SECTION 00 91 02
ADDENDUM NUMBER 2

DATE: AUGUST 30, 2022
PROJECT: KEN PICKERILL HOUSE RENOVATIONS
6350A MINKLER ROAD
YORKVILLE, ILLINOIS 60560
PROJECT NO: 19-429-1250
OWNER: KENDALL COUNTY FOREST PRESERVE DISTRICT
110 W. MADISON STREET
YORKVILLE, ILLINOIS 60560
TO: PROSPECTIVE BIDDERS / PLANHOLDERS OF RECORD

THIS ADDENDUM CONSISTS OF 2 PAGES AND DRAWINGS A311, A331, A700, S311, S321 & S400.

EAST CANOPY ELEVATION
SCALE: 1/8" = 1'-0" 8

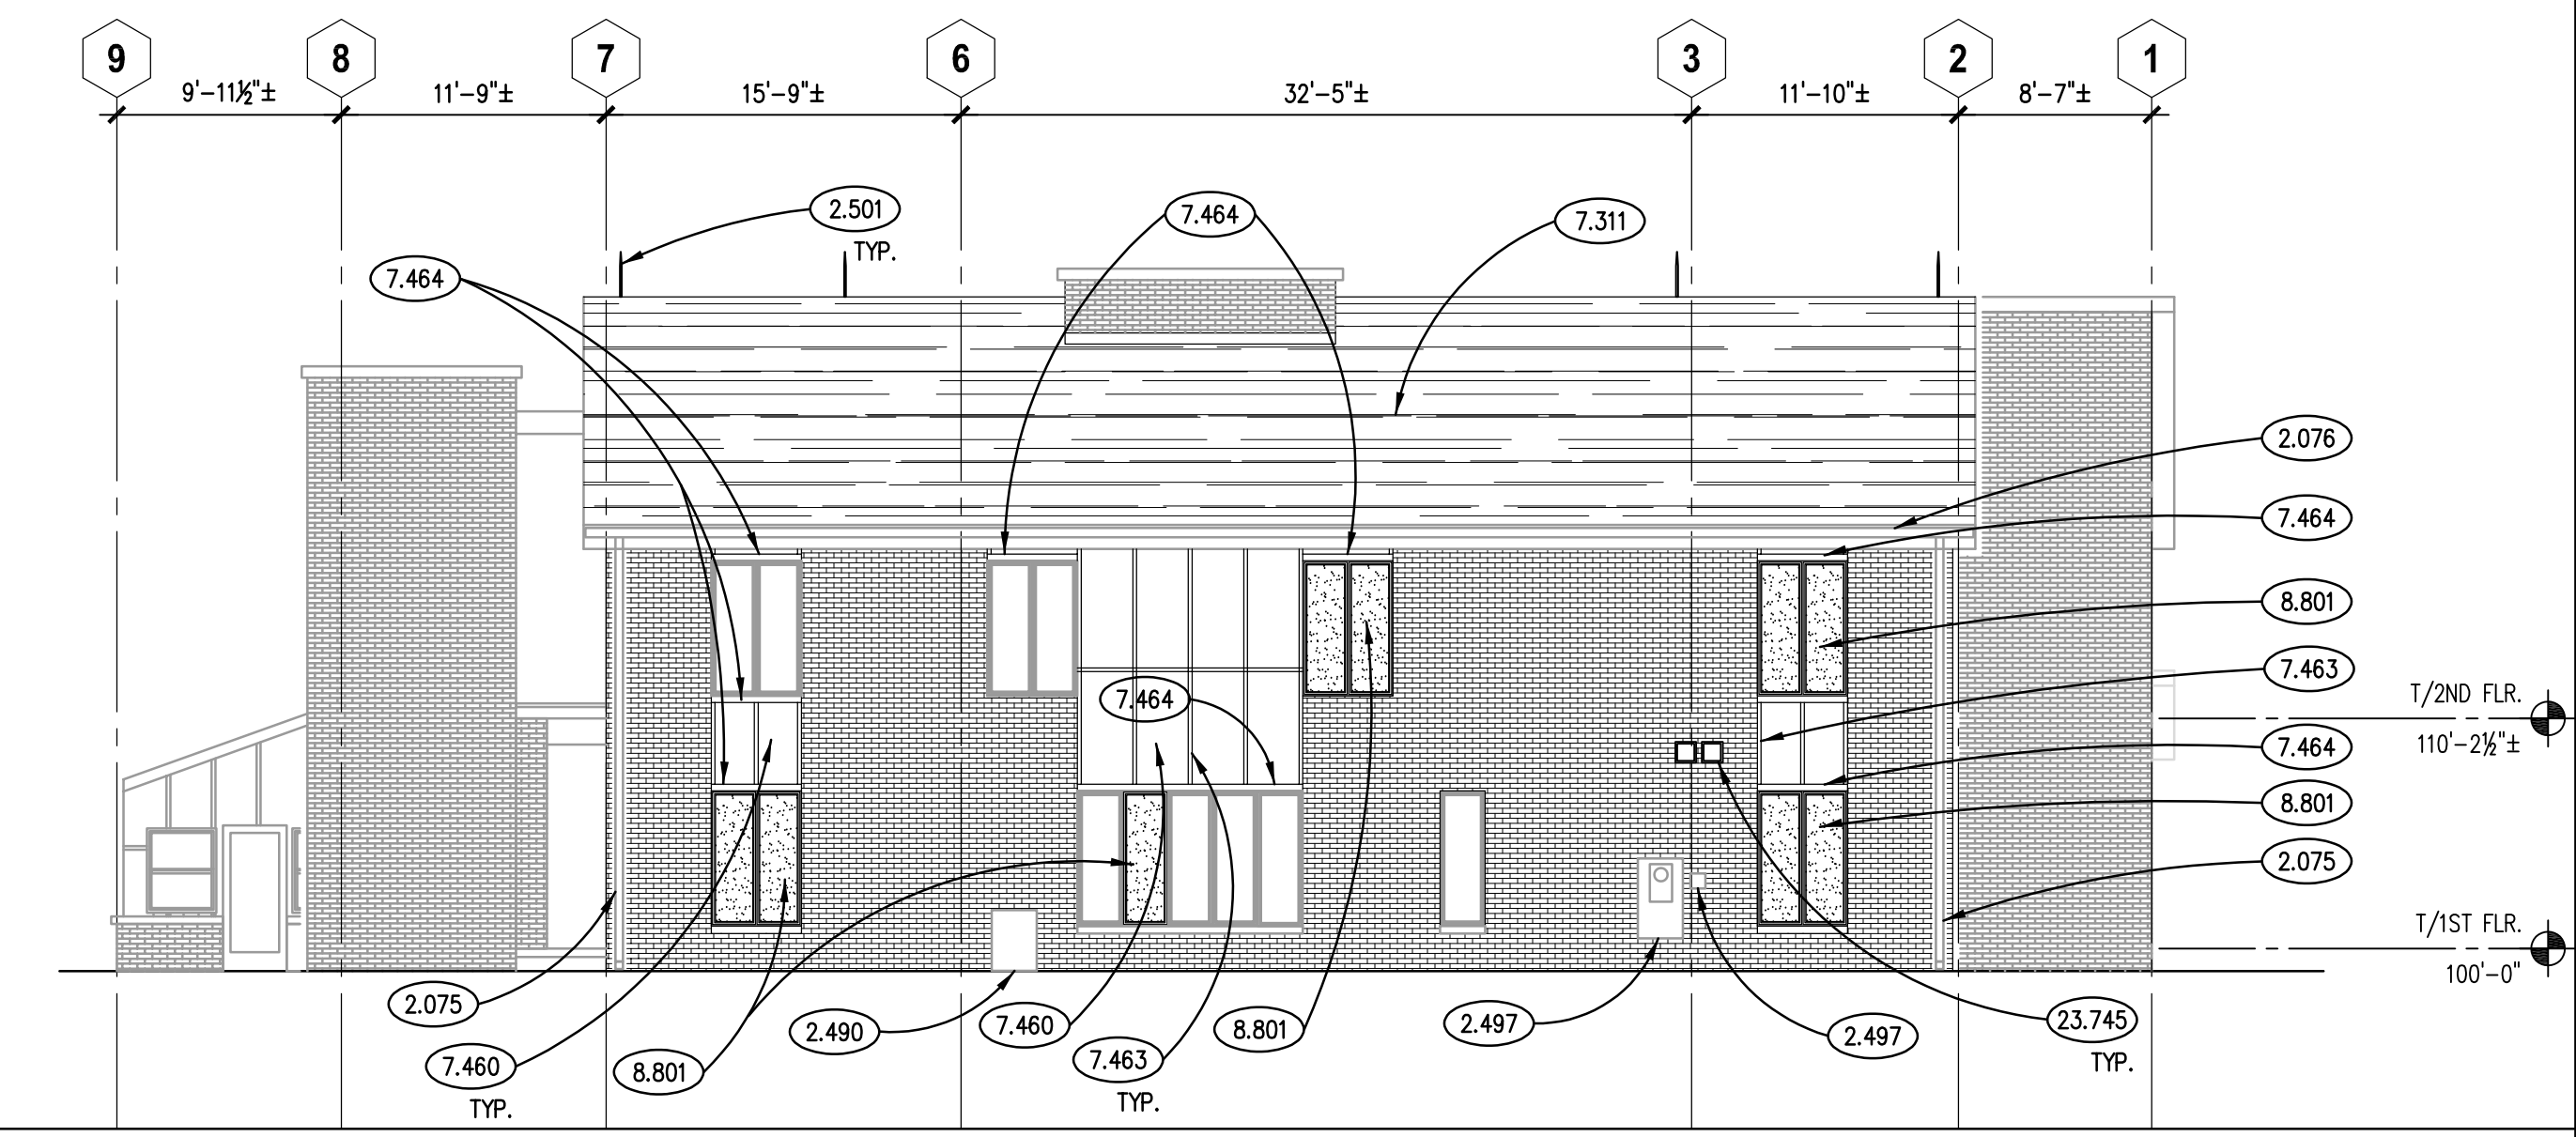
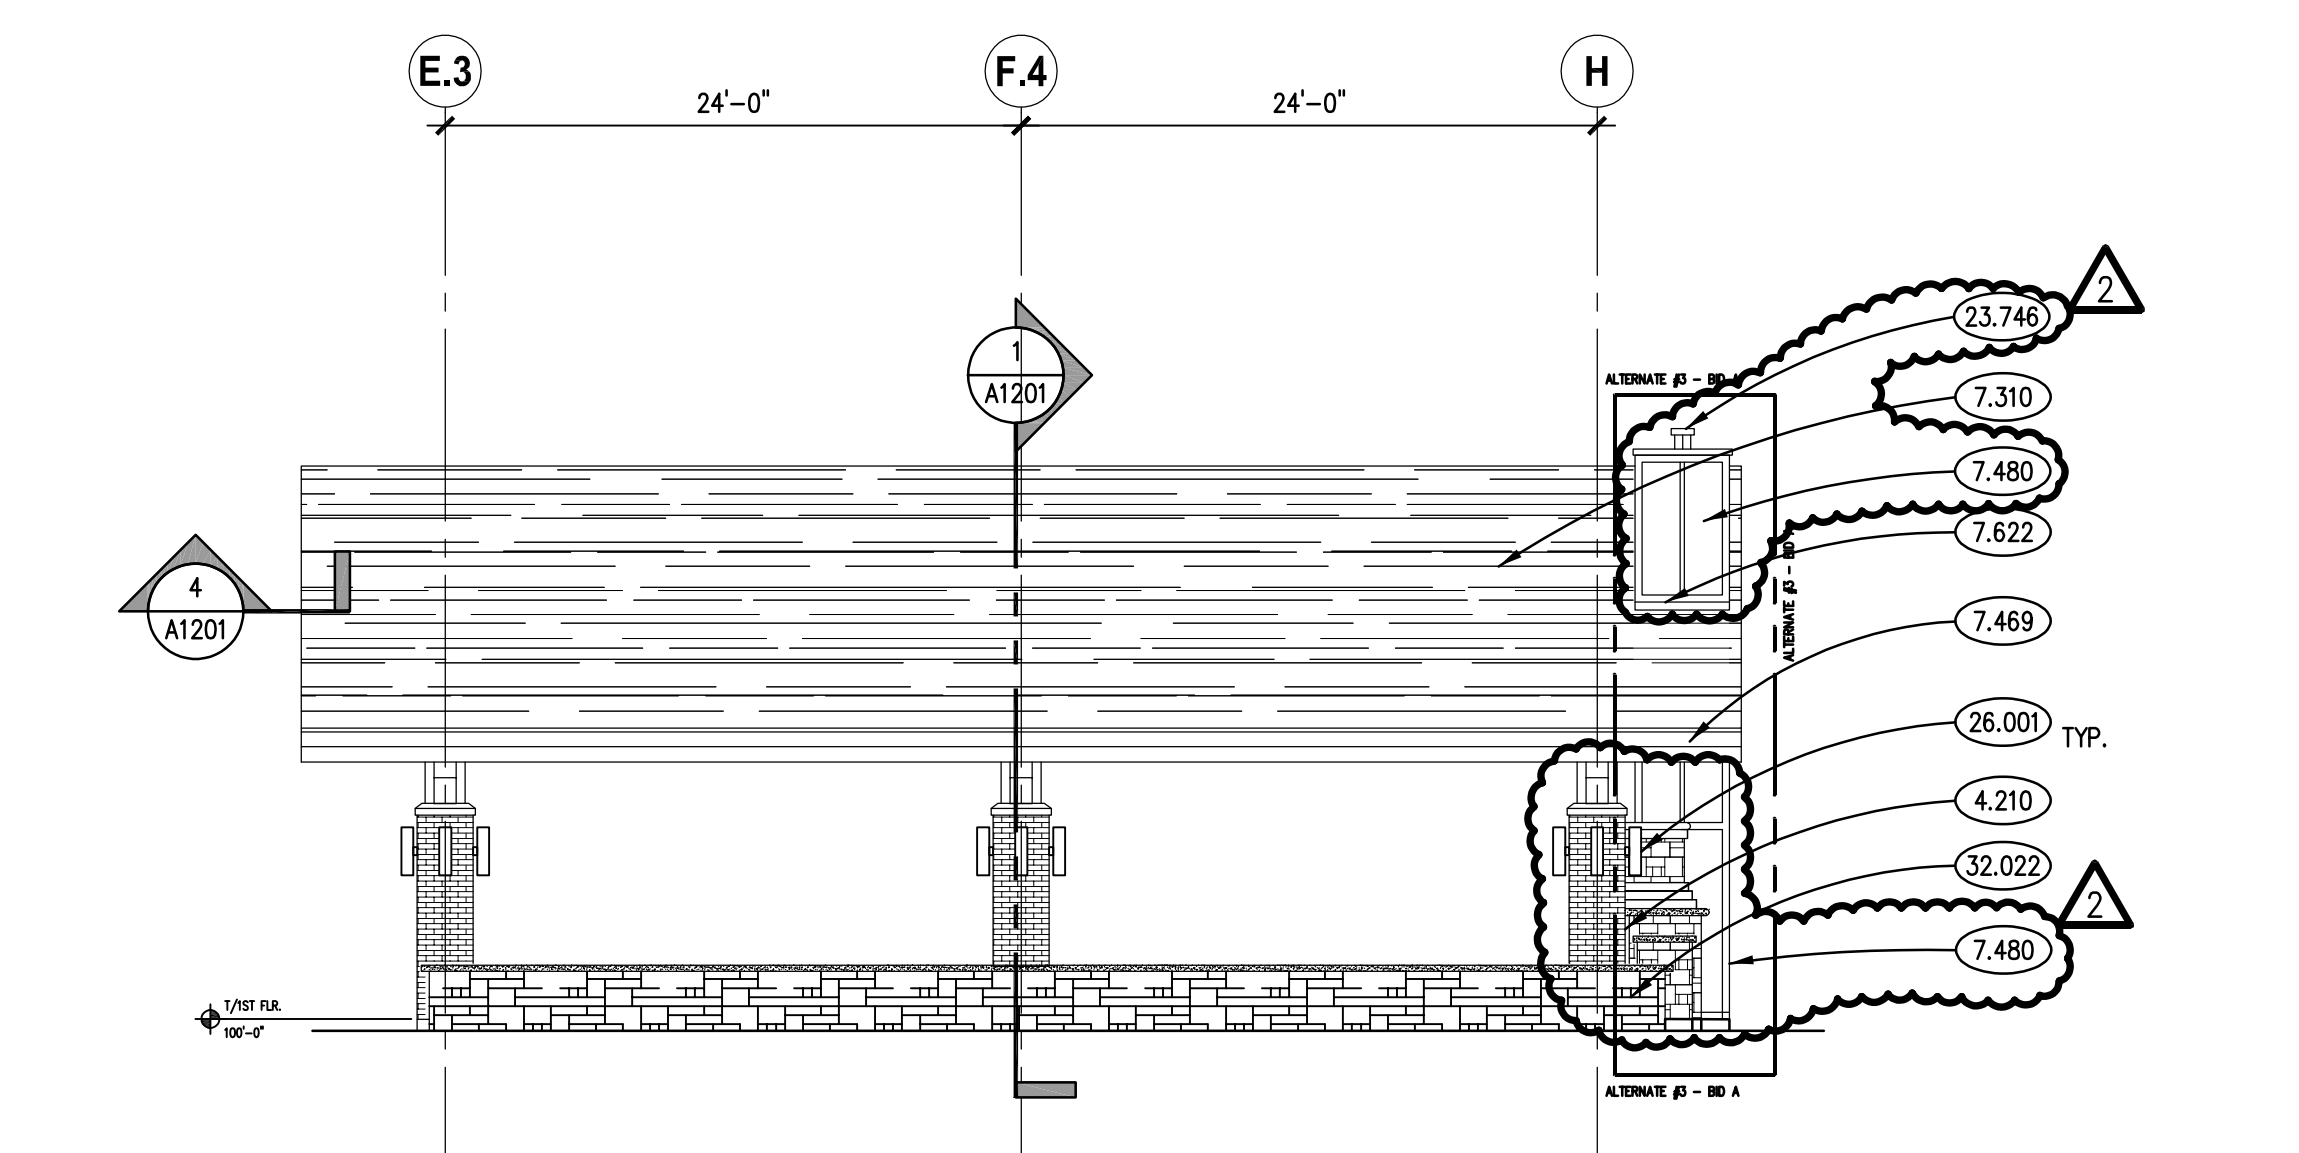
3.03 DRAWING A700 - EXTERIOR BUILDING & CANOPY ELEVATIONS

A. Revised Details 7 & 8 for fireplace chimney. The chimney above the Unilock base chimney unit is now framed with fire treated wood and encased with fiber cement siding and trim in lieu of a masonry chimney extension. Refer to added Keynotes as indicated in Revision Cloud #2.

CANOPY FOUNDATION PLAN
SCALE: 1/4" = 1'-0"

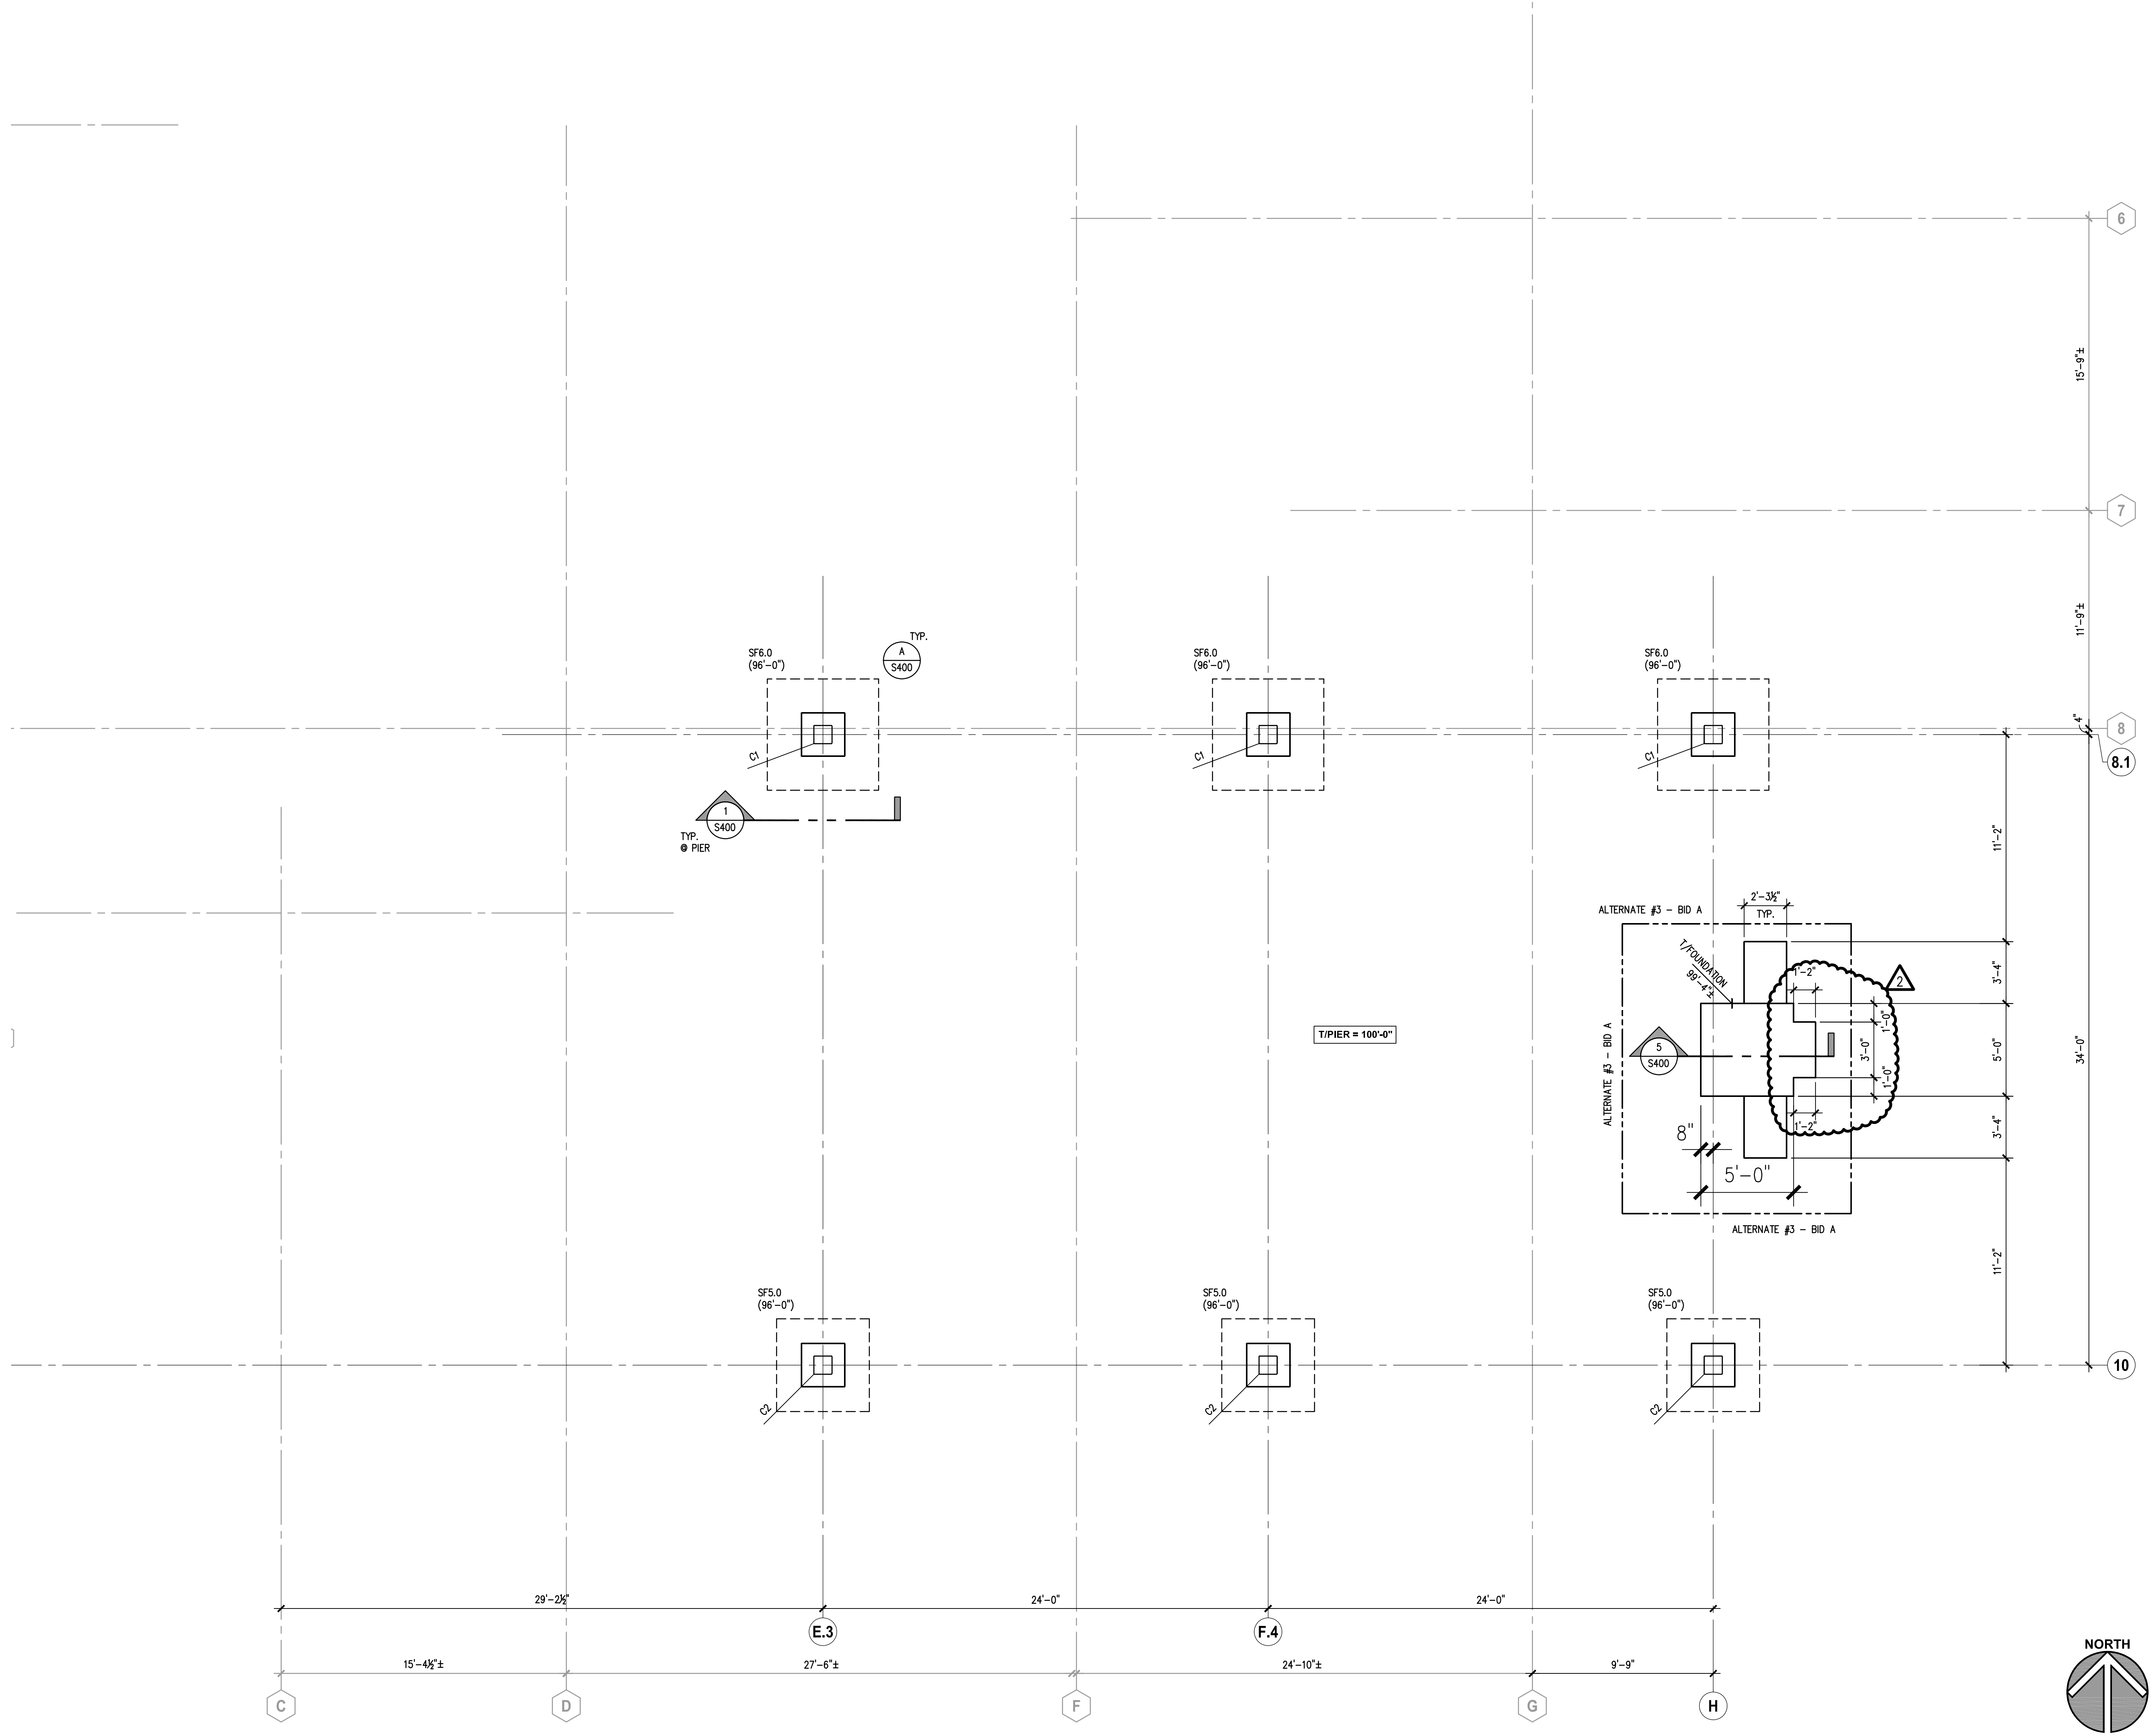
3.04 DRAWING S311 - CANOPY FOUNDATION PLAN

A. Revised Detail 1 - Canopy Framing Plan to indicate an extension on the fireplace foundation to support the wood framed chimney structure. Added dimensional information for extended foundation.
